# Access Compliance Report

### (Curb Ramps)

Intersection ID: 30109	Main Street: HARLAND_ST	Cross Street: WANDERING_CREEK_DR	Location: N
ADA ID: 0D091313DC82	Ramp Type: PerpDiag	Initial Pass/Fail: Fail	Overall Compliance: No
Severity Score: 8.75			
Codes/Mitigation Info/Possible Solution		Field Measurements/Component Compliance

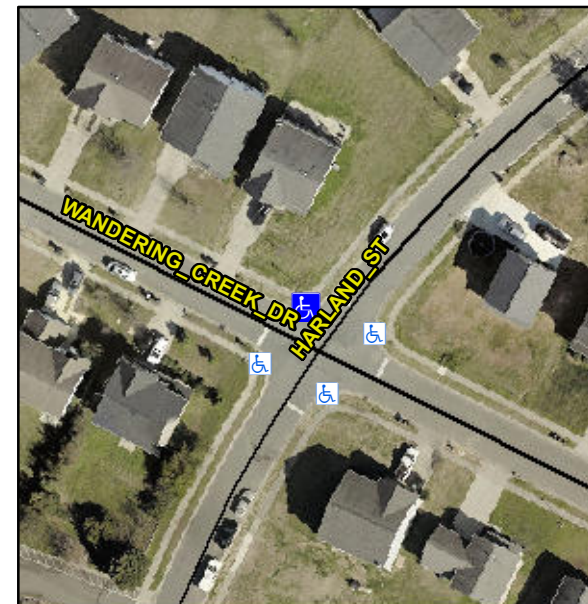
**Not Found, R304.5.1**

Compliance	Description	Data	Compliance	Description	Data
N/A	Ramp Length (in)	46.0	Yes	Ramp Slope (%)	5.1
No	Ramp Width (in)	39.0	Yes	Ramp XSlope (%)	0.3
N/A	Flare Type LT	N/A	N/A	Flare Type RT	N/A
N/A	Flare Slope LT (%)	N/A	N/A	Flare Slope RT (%)	N/A
N/A	Flare Traversable LT?	N/A	N/A	Flare Traversable RT?	N/A
N/A	Landing Length (in)	N/A	N/A	DWS Provided?	N/A
N/A	Landing Width (in)	N/A	N/A	DWS Contrast?	N/A
N/A	Landing Slope (%)	N/A	N/A	DWS Length (in)	N/A
N/A	Landing X Slope (%)	N/A	N/A	DWS Full Width?	N/A
N/A	Landing Curb? (Y/N)	N/A	N/A	DWS Offset (in)	N/A
N/A	Shared Landing?	N/A			
N/A	Gutter Ponding?	N/A	N/A	Gutter Slope (%)	N/A
N/A	Gutter Lip Ht (in)	N/A	N/A	Gutter X Slope (%)	N/A
N/A	Painted X Walk1?	No	N/A	Painted X Walk2?	No
	X Walk 1 Direction	To SW		X Walk 2 Direction	To SE
N/A	X Walk 1 Width (in)	N/A	N/A	X Walk 2 Width (in)	N/A
	X Walk 1 Slope (%)	4.3		X Walk 2 Slope (%)	1.4
	X Walk 1 X Slope (%)	3.4		X Walk 2 X Slope (%)	5.8

**Remove & Replace Curb Ramp With Two New Directional Ramps or Equivalent.**
